ENGINEERING CHANGE NOTICE

1. ECN **657726**

Site-Specific SST Phase 1 RFI/CMS Work Plan Addendum for WMAs T and TX-TY

SITE-SPECIFIC SST PHASE 1 RFI/CMS WORK PLAN ADDENDUM FOR WMAs T and TX-TY

Figure 6.1. Preliminary Characterization Schedule

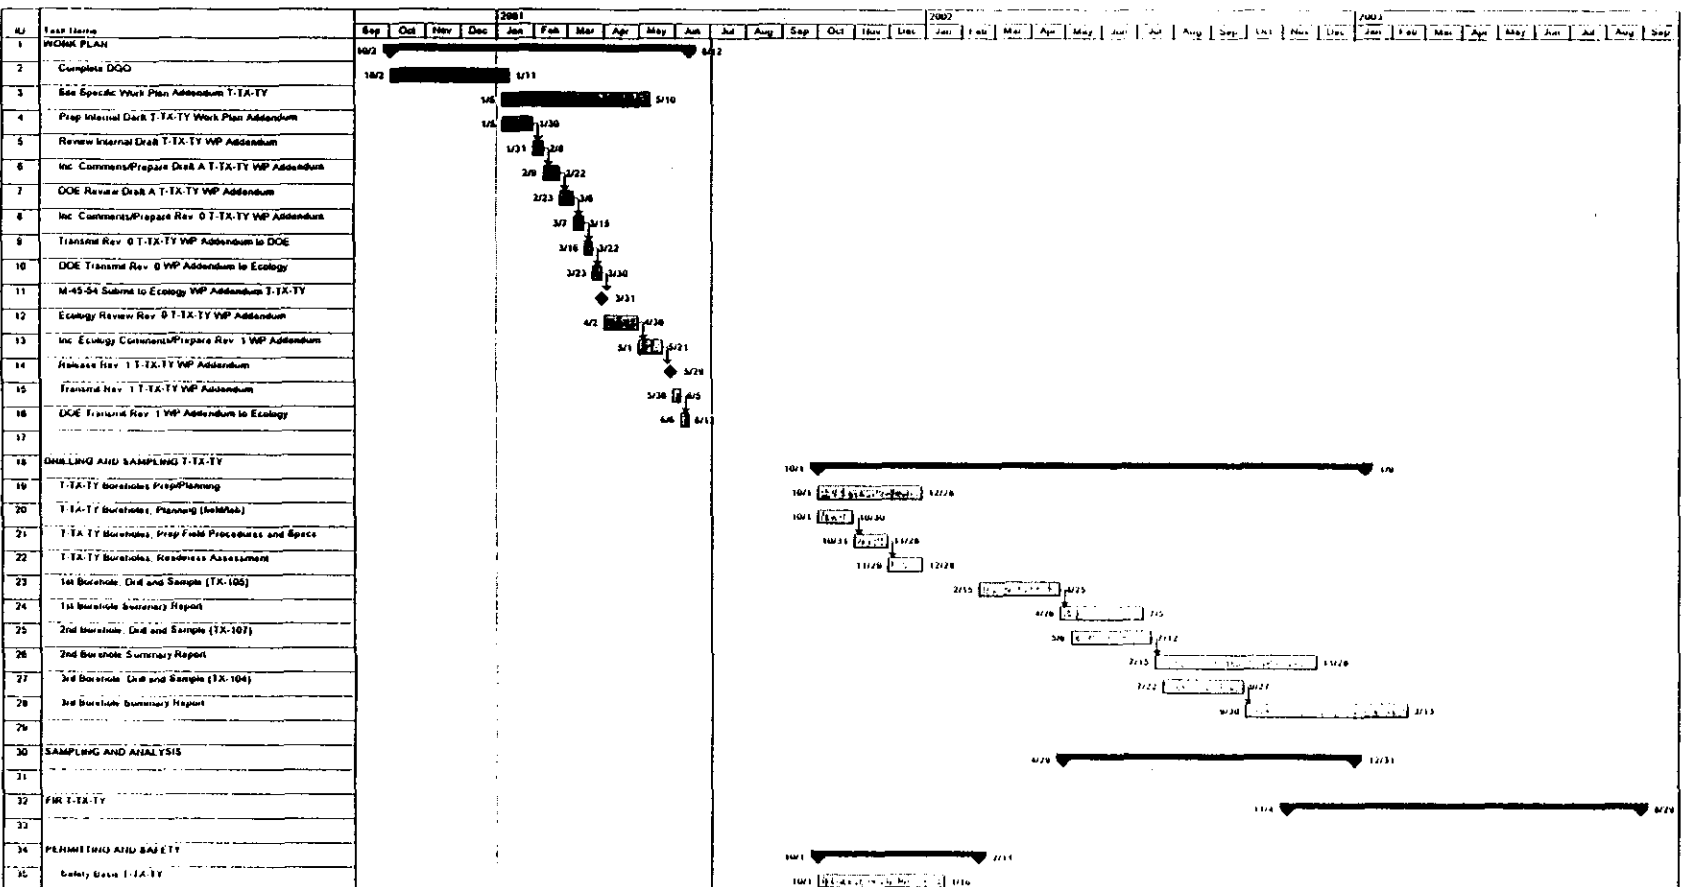
13a. Description of Change Pages 4-4, 5-4, A-1, and A-9 were revised to reflect maximum depth of sampling and number of samples collected. Figure 6-1 and page A-6 were revised to ensure schedule of field activities can be accomplished during fiscal year 2002.	13b. Design Baseline Document? <input type="radio"/> Yes <input checked="" type="radio"/> No
---	--
